## Lawrence Berkeley National Laboratories Peer Review

**Peer Review of Groundwater Modeling for the  
Monterey Peninsula Water Supply Project (MPWSP) April 2015 Draft EIR**

October 31, 2016

**Figure B1.** Storativity distribution in each layer of the NMGWM, plotted from *nm\_sce3n\_1.lpf*. Compared to Figure 33 of App. E2, these storativity values tend to be lower.

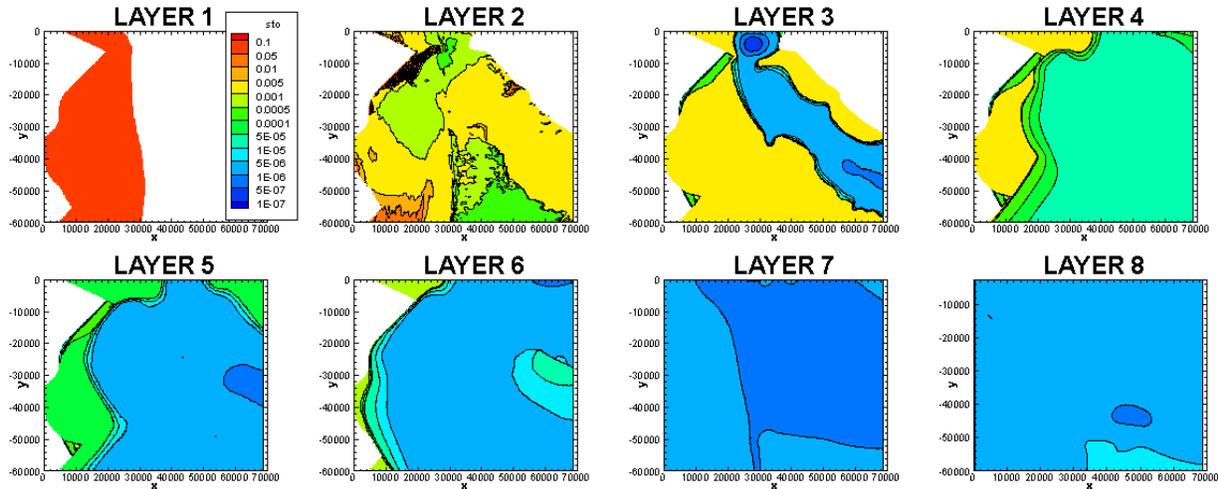
LPF – layer properties. Provides distributions of hydraulic conductivity, vertical hydraulic conductivity, and primary storage for 8 model layers. Horizontal hydraulic conductivity values are consistent with Figure 31 of App. E2. Vertical hydraulic conductivity values are consistent with Figure 32 of App. E2, except for one small region in the upper left corner of Layer 1 where Figure 32 claims vertical conductivity is between 0.21 and 0.40, but the file indicates it is 4. Storativity values are not consistent with Figure 33 of App. E2, but tend to be much lower, as shown in **Figure B1** in this report.

**Figure D1.** The eastern half of Section 1-1' with data gaps regarding continuity of the aquitard between the Dune Sand and 180-FTE Aquifer indicated.

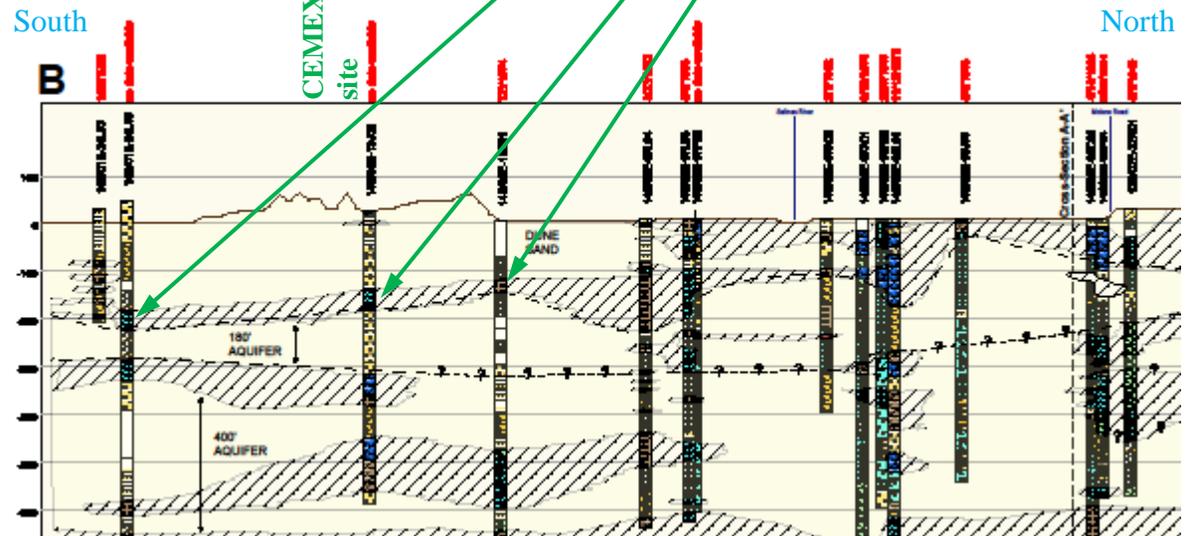
The hydrostratigraphy in the vicinity of the CEMEX site is represented on east-west cross section 1-1’ and north-south section A-A’ in Appendix E2. The portion of Section 1-1’ shown on **Figure D1** indicates there is an aquitard between the Dune Sand and 180-FTE aquifers approximately two miles east of the site. It is possible this aquitard extends to the CEMEX site as there are no logs plotted on the section between the interpreted western edge of this aquitard and the site. There is also a well log plotted at the eastern edge of the CEMEX site (14S/2E-18E1) that has a 25-foot thick clay at the approximate position of this aquitard.

The eastern edge of this aquitard is shown on Section 1-1’ as disconnected from the Salinas Valley Aquitard (SVA). However no log is plotted between the easternmost well with this aquitard (14S/2E-21E01) and the westernmost well with the SVA (14S/2E-21F02) to support this interpretation.
